DRAFT ADA SELF-EVALUATION AND TRANSITION PLAN

CALIFORNIA TAHOE CONSERVANCY

DECEMBER 2018

*Accessibility Compliance Evaluation completed by:
California Department of General Services
Real Estate Services Division
Professional Services Branch, Arch Unit B
Eric Driever, Senior Architect, CASp*

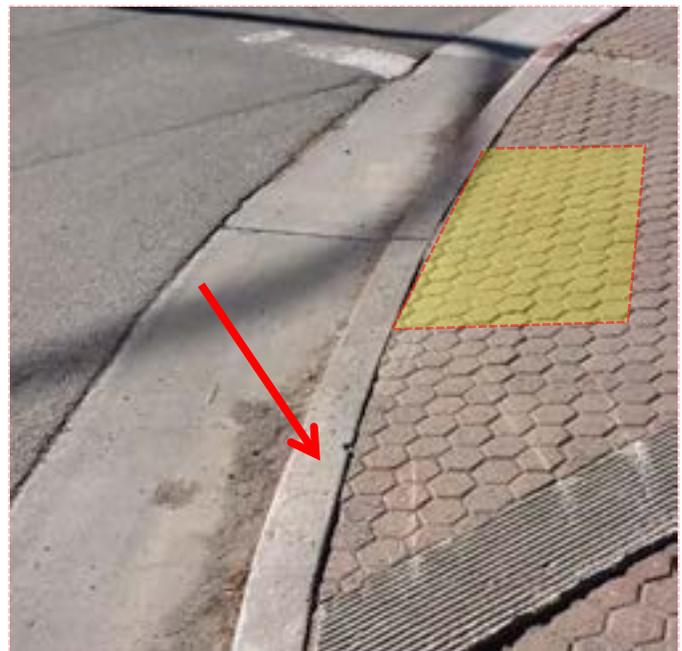
Grate and cross slopes are non-compliant.

Excessive vertical change exists in walkway.

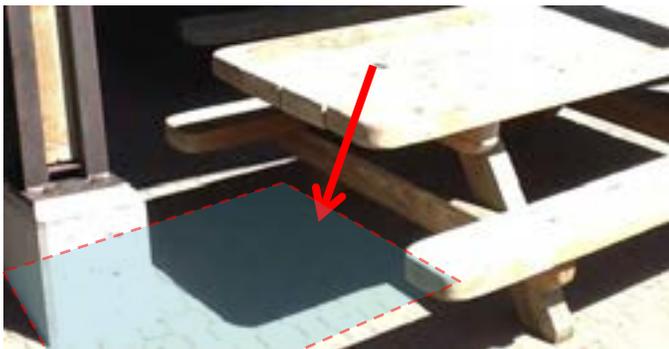
Inadequate clear space is provided on the approach to the accessible table. An accessible picnic table must provide a 30"x48" wheelchair space and provide for the allowed knee space within those limits.

The current layout does not provide the required 36" clear space between and around the tables.

Site Plan: Location of accessible routes of travel on site.

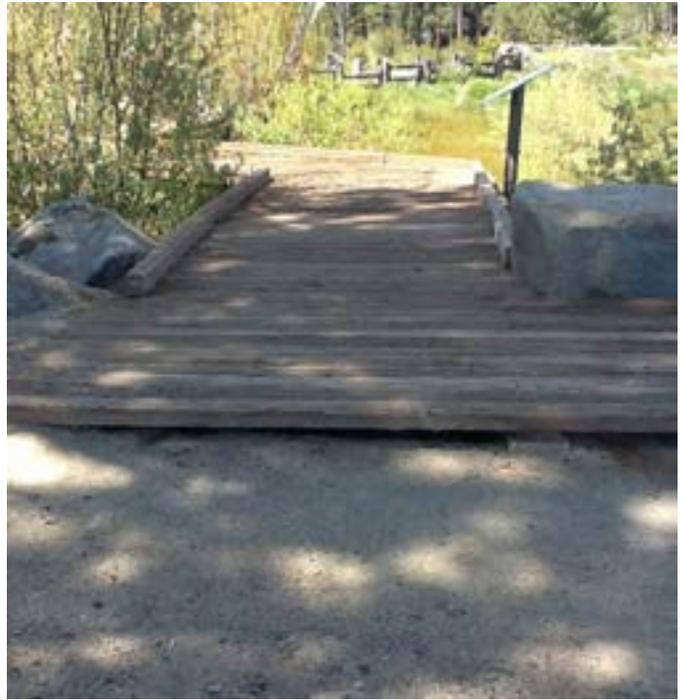
Storage reduces the path of travel to less than 48" minimum clear.

Flush transition to vehicular way lacks truncated domes.

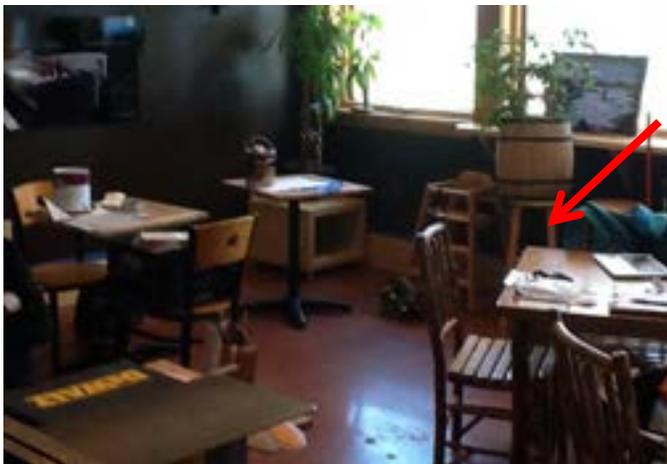
Outdoor counter height is greater than 34" with no lower accessible portion.

The standing eating area does not provide a lower section (34" maximum height) for wheelchair users.
